ADDENDUM NO. TWO  
NCSB -FBMS

To the Plans and Specifications for:  
Nassau County School Board – Project No. 98110-031  
Fernandina Beach Middle School Kitchen / Dining Remodeling and Campus  
Renovations/Enhancements

Date: October 16, 2018

M-17

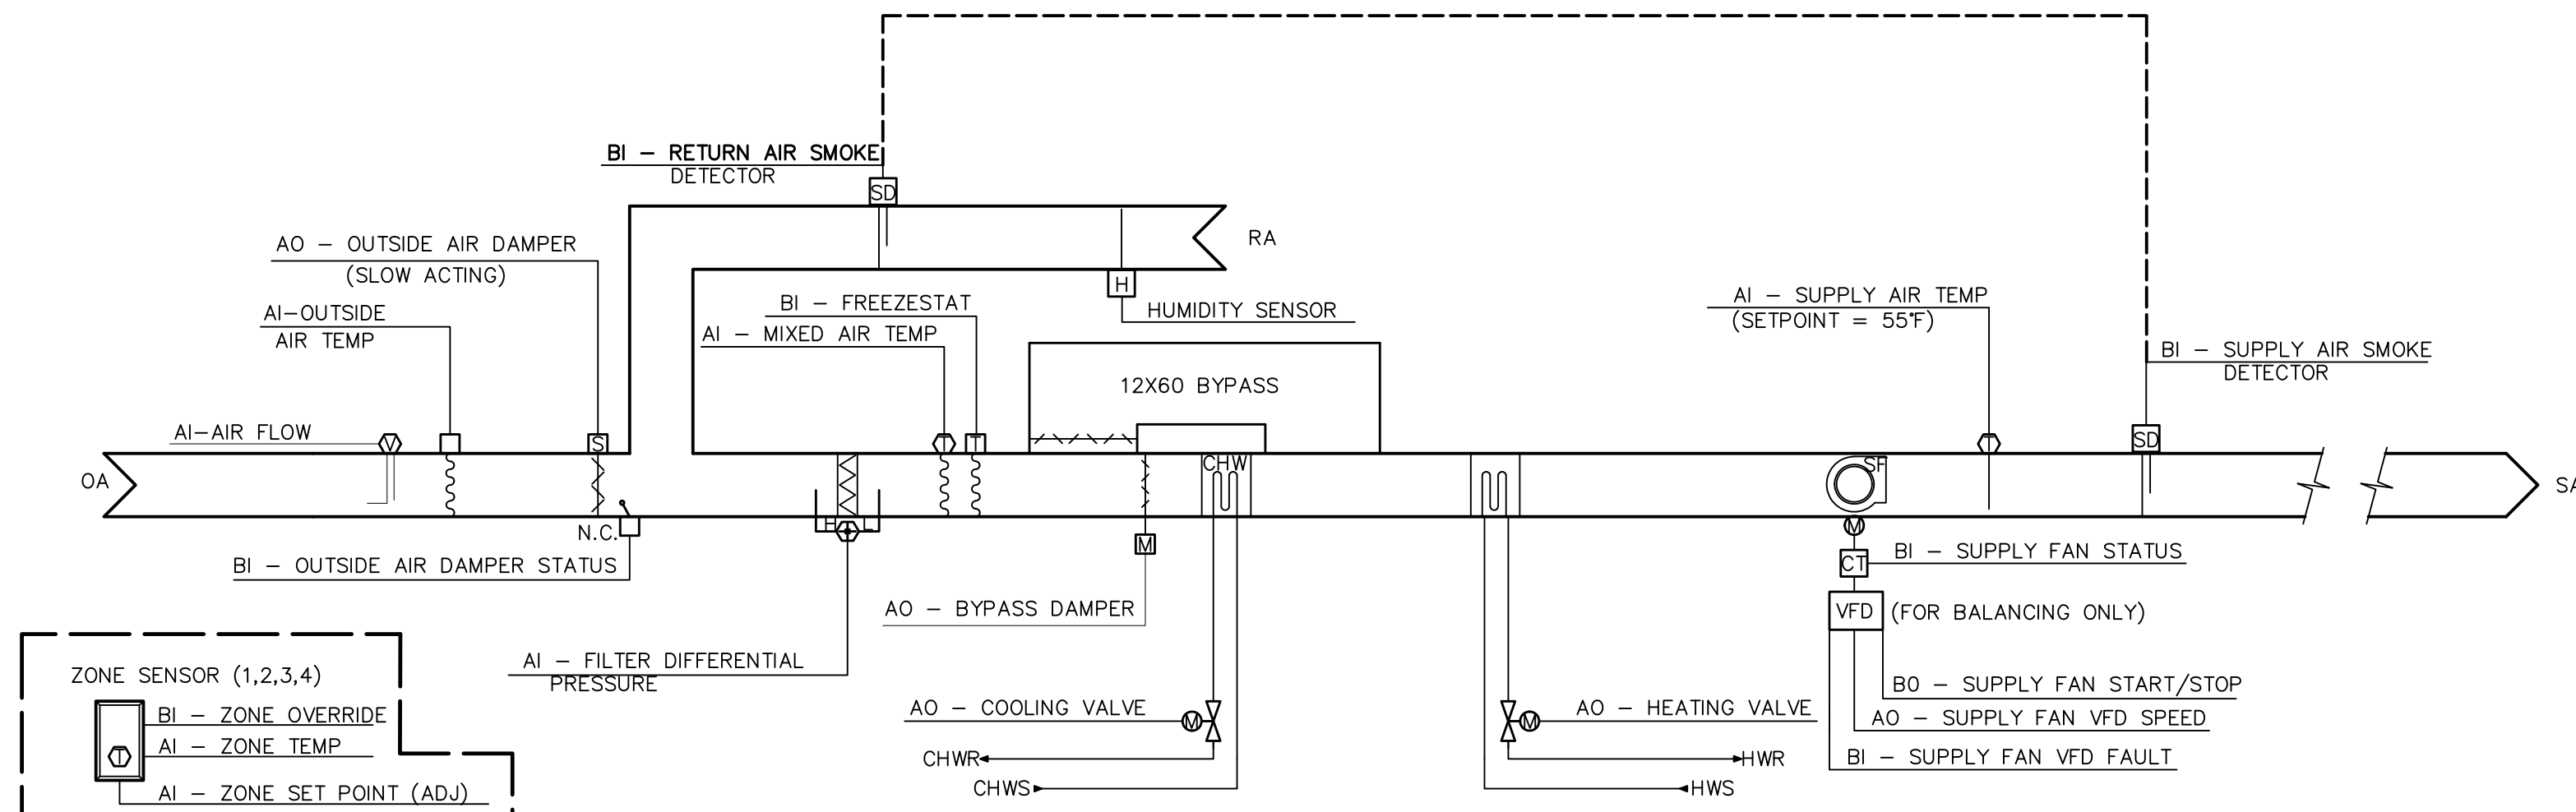
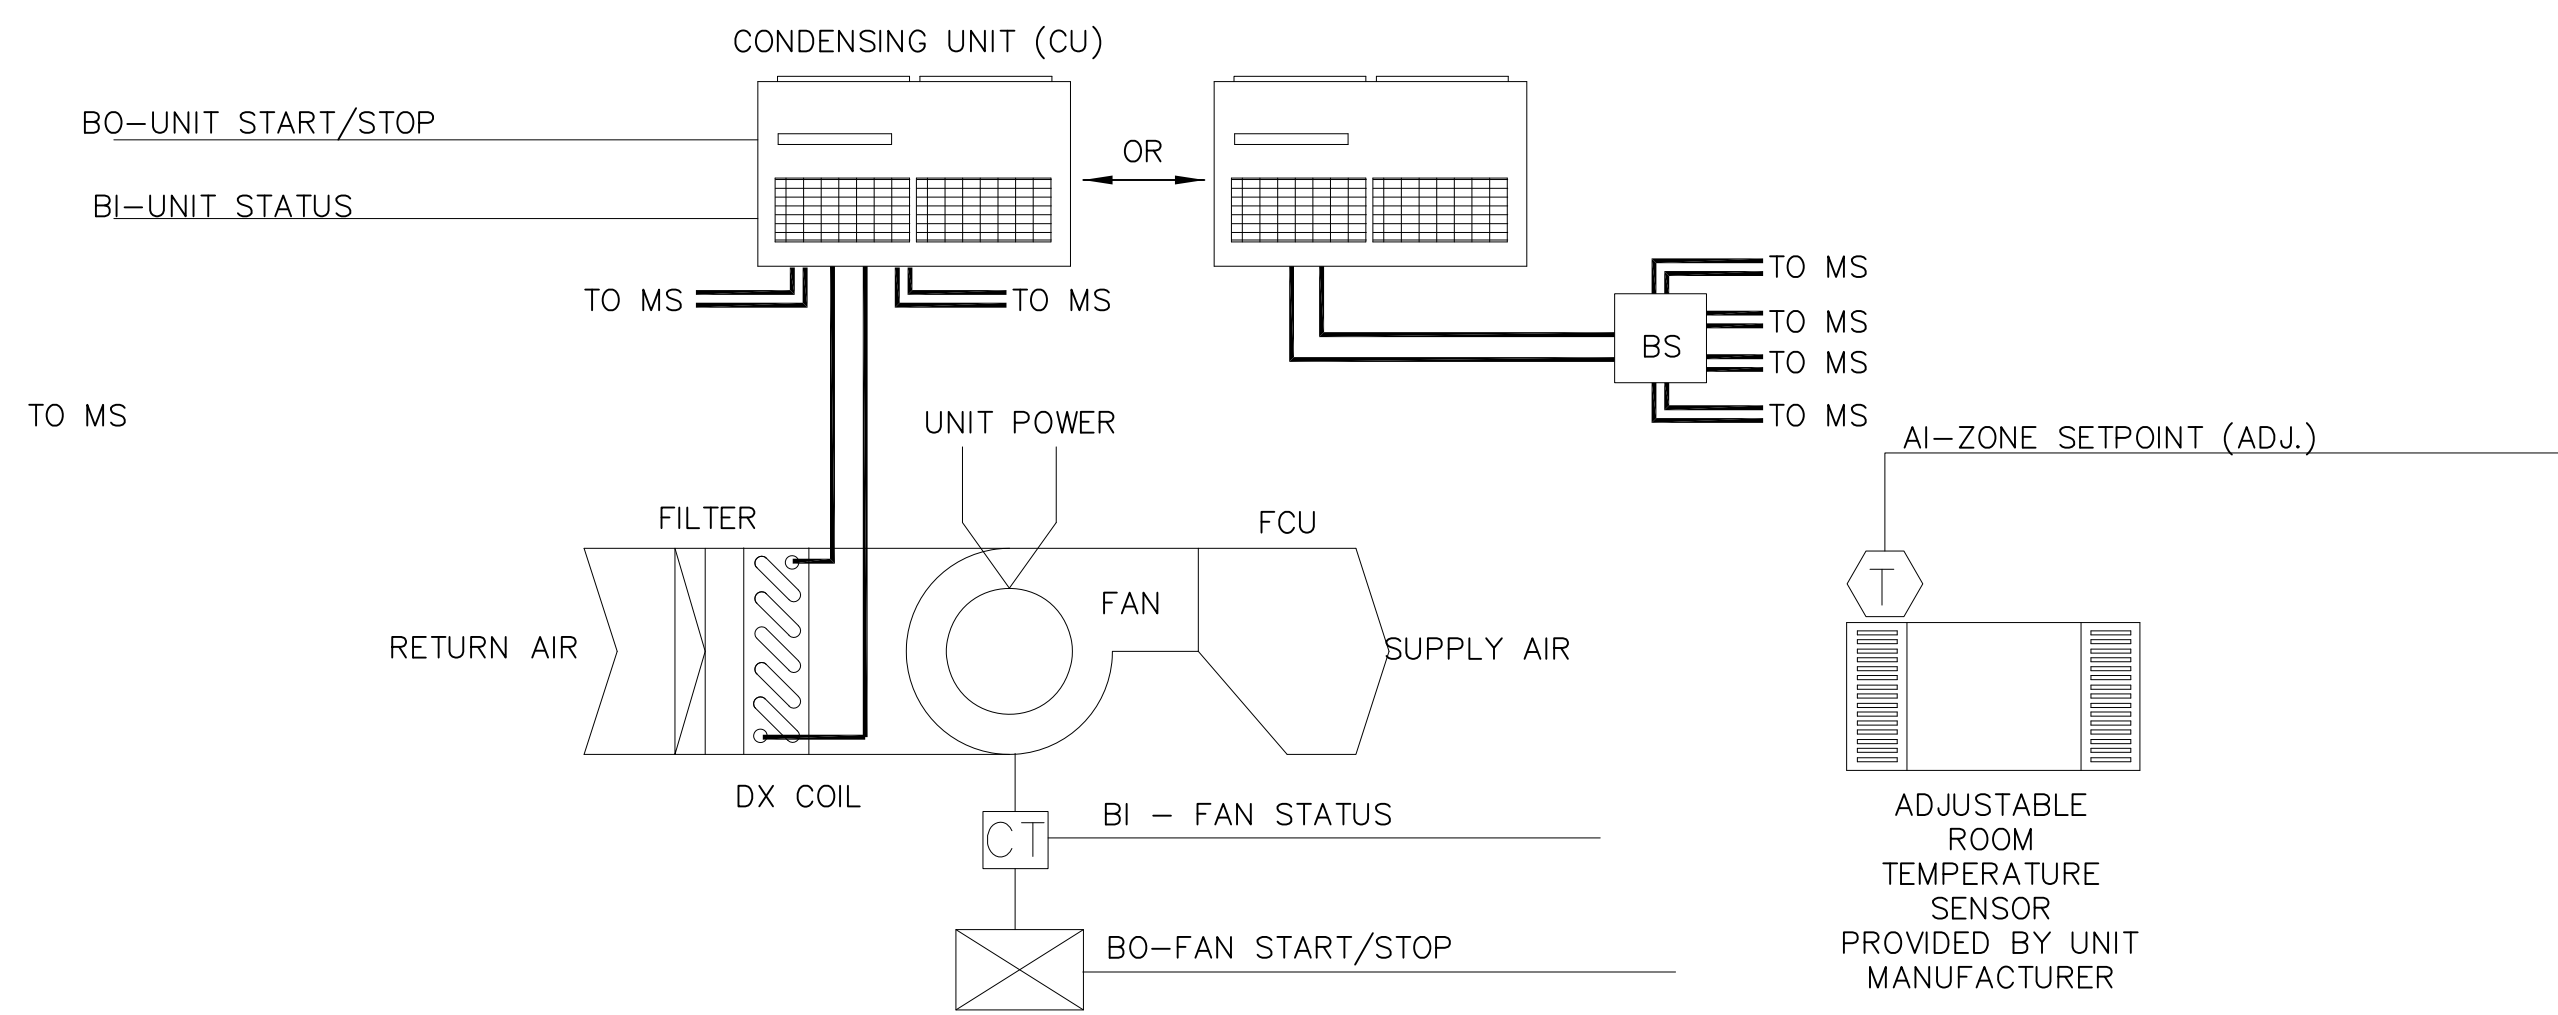
- a. Delete existing Drawing, M-17, dated 9/25/2018 and insert Drawing M-17, Dated 10/16/18.
- b. Added Note “N” bid direction.
